November 14, 2022

Object: Communication regarding Bosch steering gearbox mounting plate installation bolts

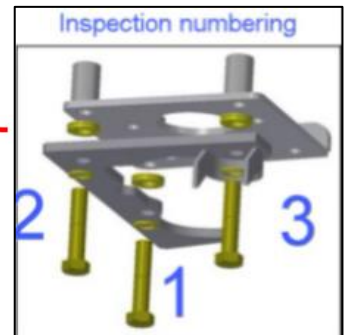
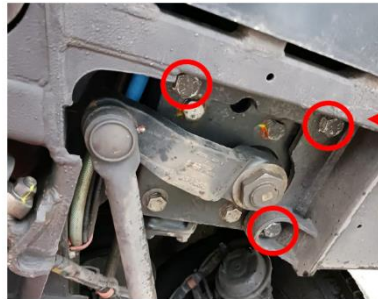
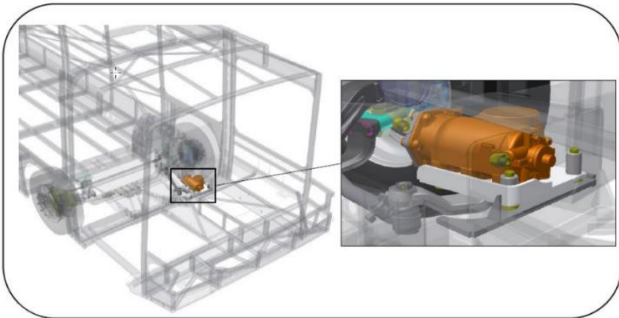
An issue was recently found on some Nova Bus vehicles equipped with a Bosch steering gearbox. The issue concerns the 7/8" bolts (3) that secure the steering gearbox mounting plate assembly to the vehicle frame.

- Visual inspection to confirm the presence of the three (3) bolts;
- Visual inspection to confirm the torque seal marks are not broken on these bolts;
- Torque inspection and retorquing of these bolts to the nominal value of 452 N.m.
- Apply new torque seal marks to the bolts.

If you identify any non-conformity during inspection, we request pictures, location and any other relevant information be communicated to Nova Bus for further analysis. All results should be reported back to your Nova Bus service representative (see pictures above for inspection numbering).
